Title: ERID-111328 SUBMITTAL OF THE RESPONSE TO THE NOTICE OF DISAPPROVAL FOR THE INVESTIGATION WORK PLAN FOR LOWER PAJARITO CANYON AGGREGATE AREA AND REVISION 1, INCLUDING 2 CD'S, EP2010-0521, EP2010-0522, LA-UR-10-7635

To:(Addressees - Organization) JAMES BEARZI, NMED

From:(Senders - Organization) MICHAEL J GRAHAM, LANL
 GEORGE J RAE, DOE

Figure 4.20-2 Proposed sampling locations for AOC 18-010(e)

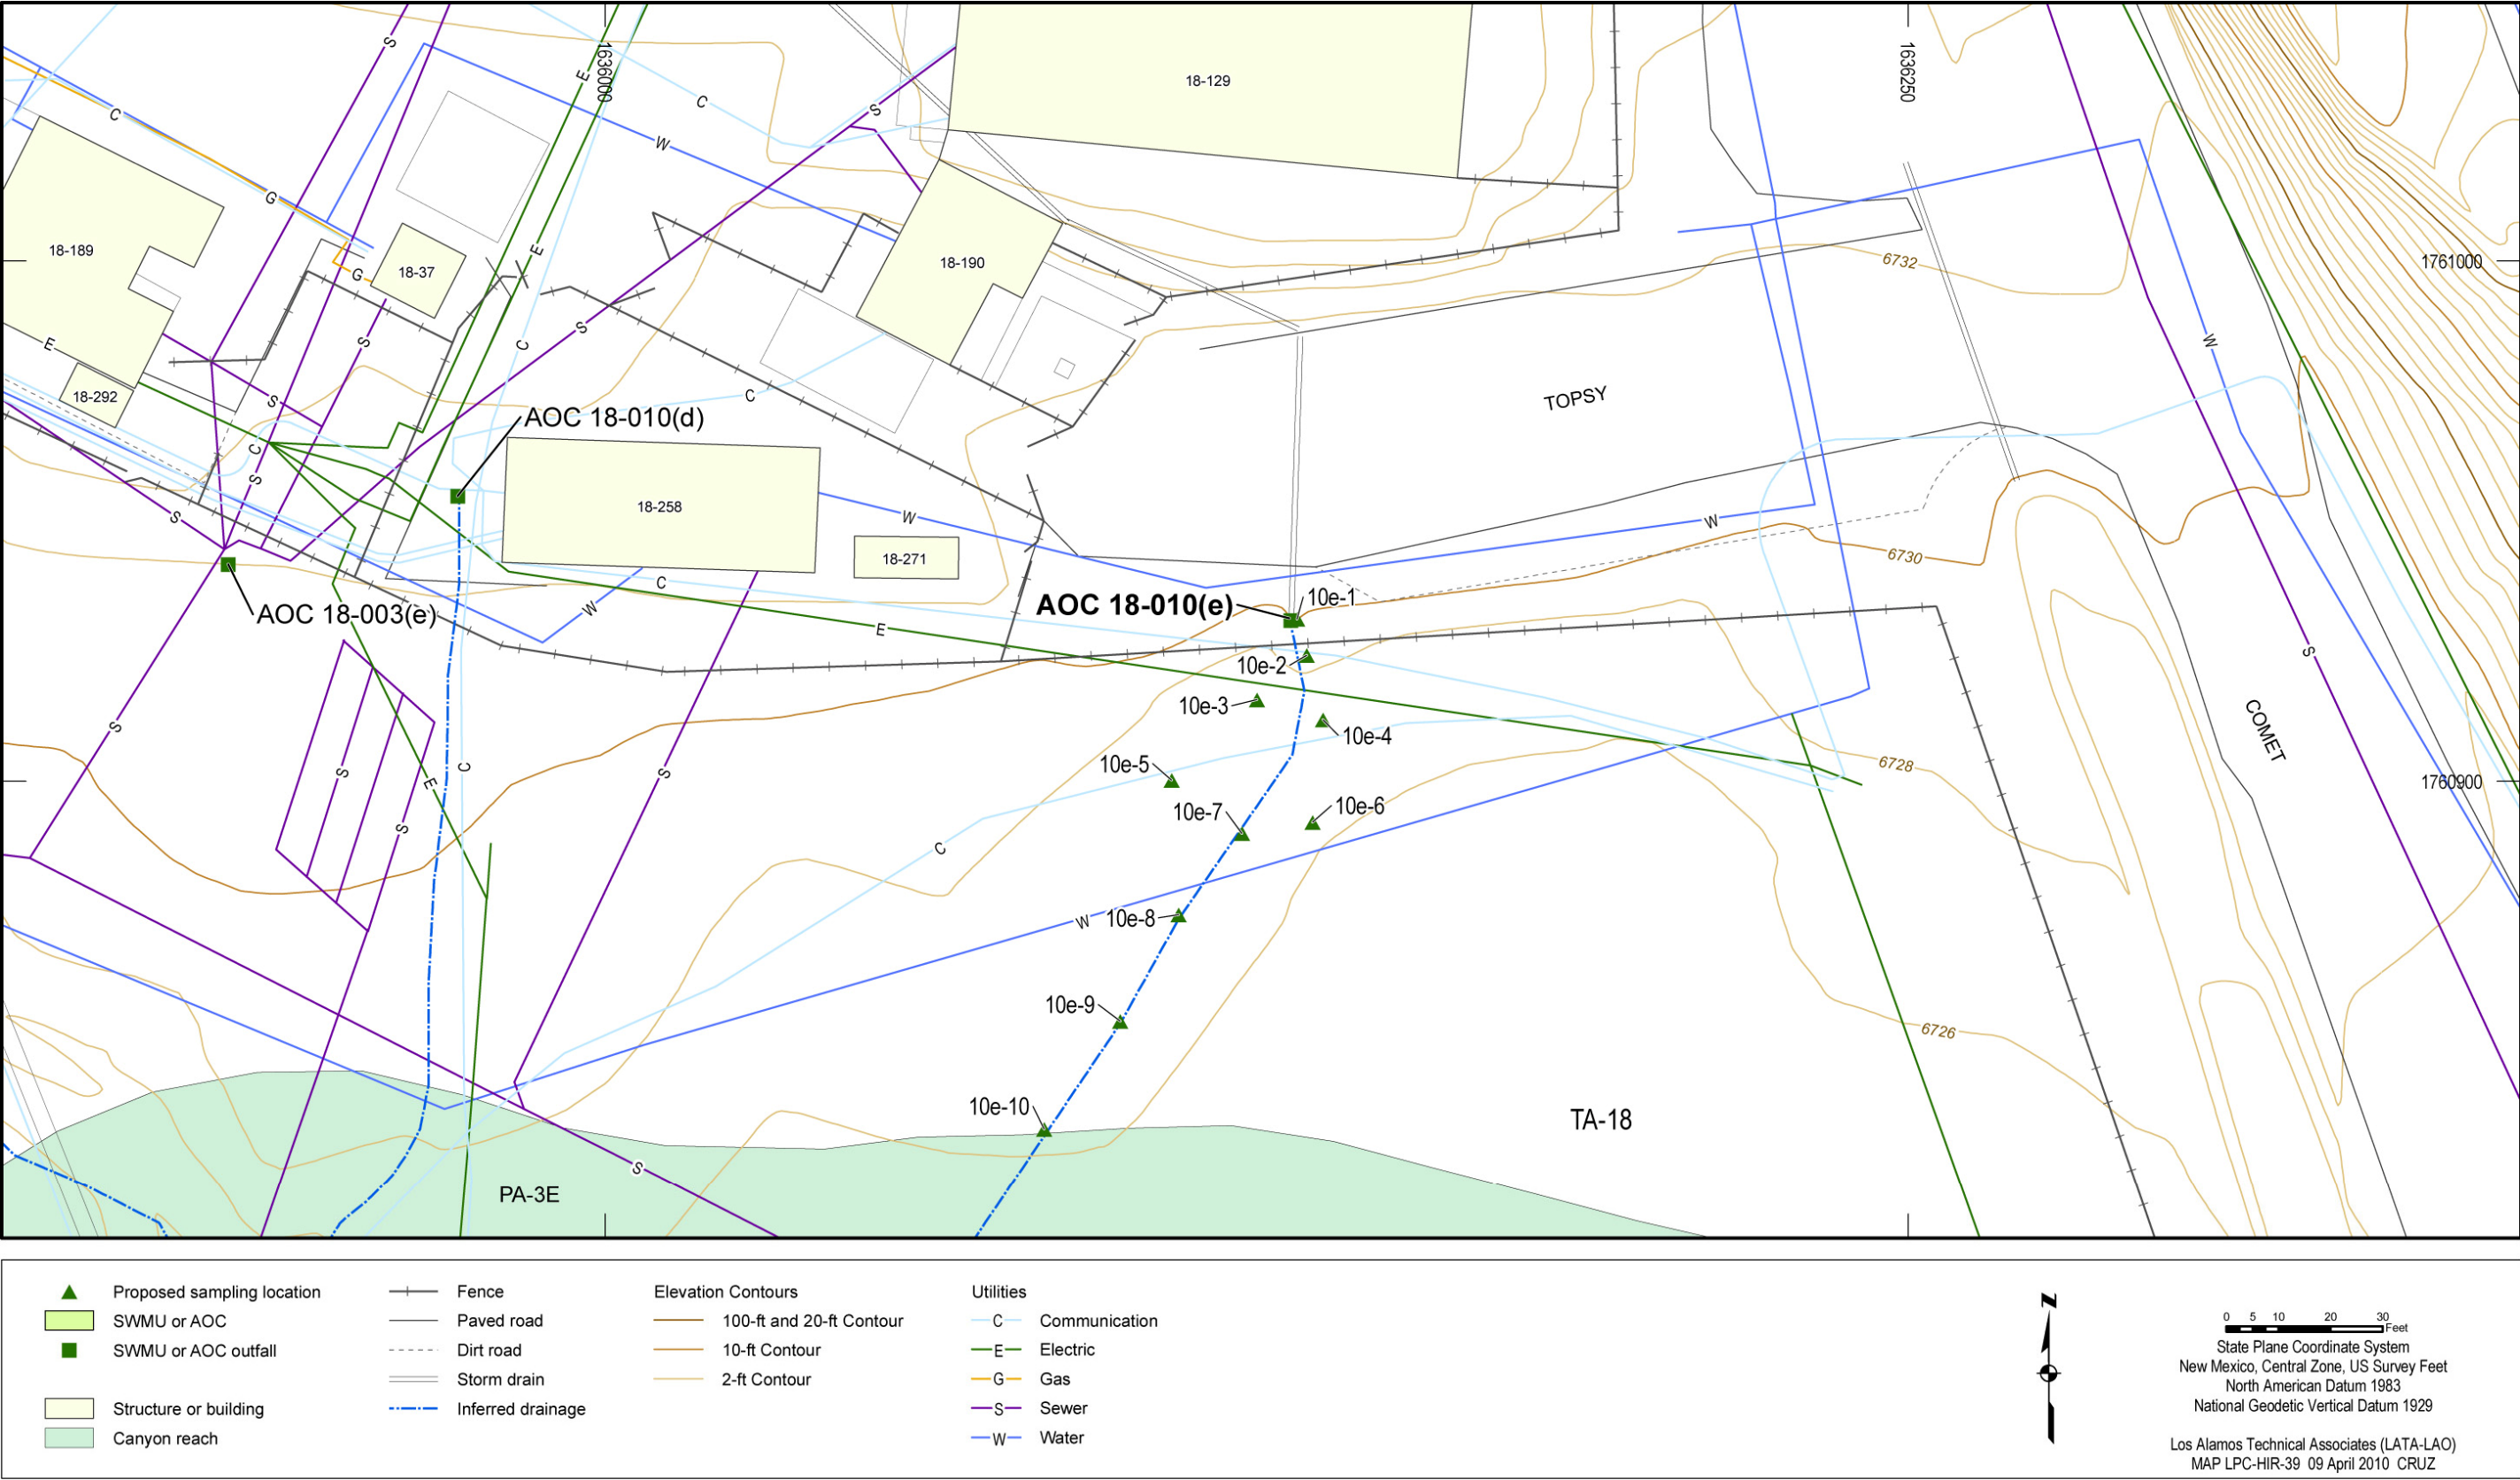
- 32. Section 4.20.3, Scope of Activities for AOC 18-010(e), first and second sentences, page 39, Figure 4.20-2, page 115, and Table 4.20-1, page 171:**

NMED Comment: Provide the proposed sample interval information for the 20 samples that will be collected in the vicinity of the outfall sample location and revise Table 4.20-1 to match the text statements. NMED assumes the outfall location where 20 sample intervals are proposed is location 10e-1 on Figure 4.20-2; however, as illustrated on Figure 4.20-2, the area designated as the AOC (outfall) location does not indicate that a sample location exists. Revise the text and the figure for clarity.

32. Twenty samples are not proposed at the outfall location, but 20 samples total are proposed for the site. The text in section 4.20.3 has been revised to clarify that samples are proposed from 2 depth intervals (0–1 ft and 2–3 ft bgs) at each of 10 locations—1 location at the outfall, 7 locations in the drainage, and 2 locations in the main channel. Figures 4.20-1 and 4.20-2 have been revised such that the AOC 18-010(e) label is now at proposed sample location number 10e-1, which is the actual location of the outfall. The accurate location of the outfall was confirmed through field verification. No revision to the table is necessary.
